TECHNICAL SERVICE BULLETIN

SUBJECT: AC50-55 INCORRECT COUPLING FLANGE STUDS

Products Affected: CN201154, shipped in December 2008 and January 2009

Effective Date: 4-FEB-2009

Below are examples of the incorrect and correct studs.

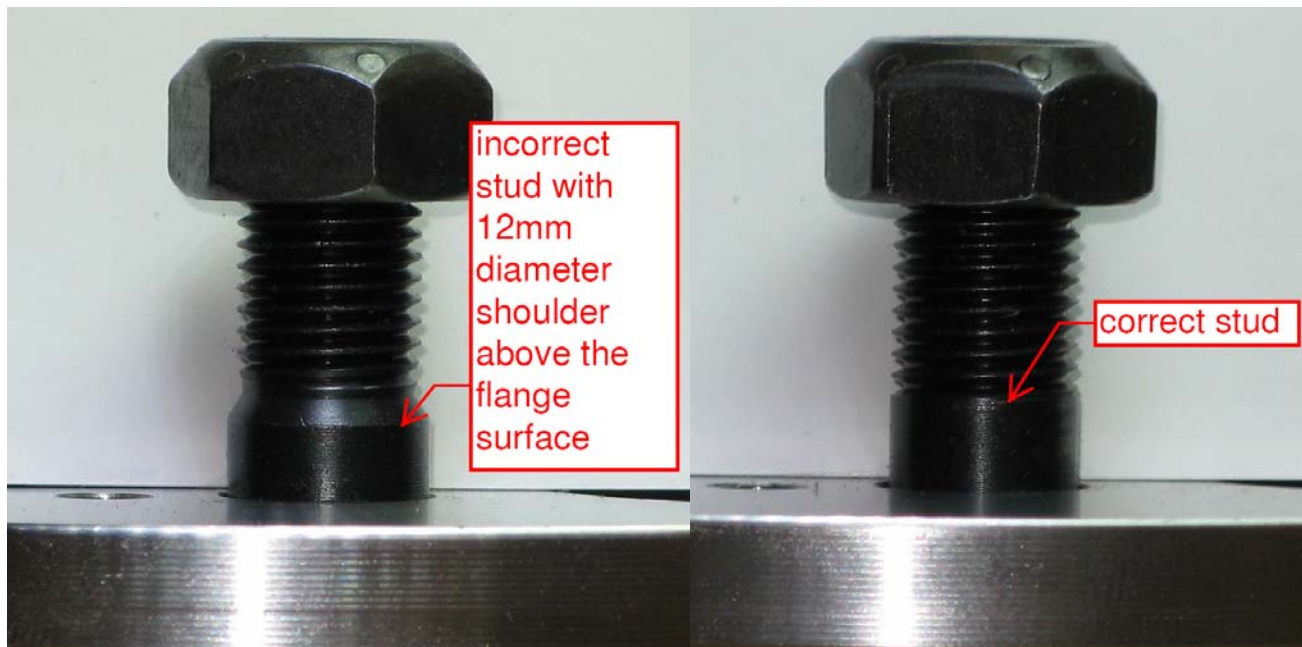
Telma model CN201154 shipped in December 2008 and January 2009 may have incorrect studs installed. On some units the flange studs may have an incorrect shoulder dimension. The problem did not occur in serial number sequence.

The incorrect stud has a shoulder diameter of 12mm which extends above the surface of the retarder flange face and does not allow the correct mating of flange yoke to the Telma companion flange.

On models that have the incorrect studs installed it is permissible to increase the diameter of the four holes of the flange yoke to 0.488 - 0.500 inches. This can generally be accomplished by using a ½" drill bit to increase the hole size in the flange yokes.

Note: Remove all burrs and metal shavings from the flange yoke to ensure a good mating of the two metal surfaces.
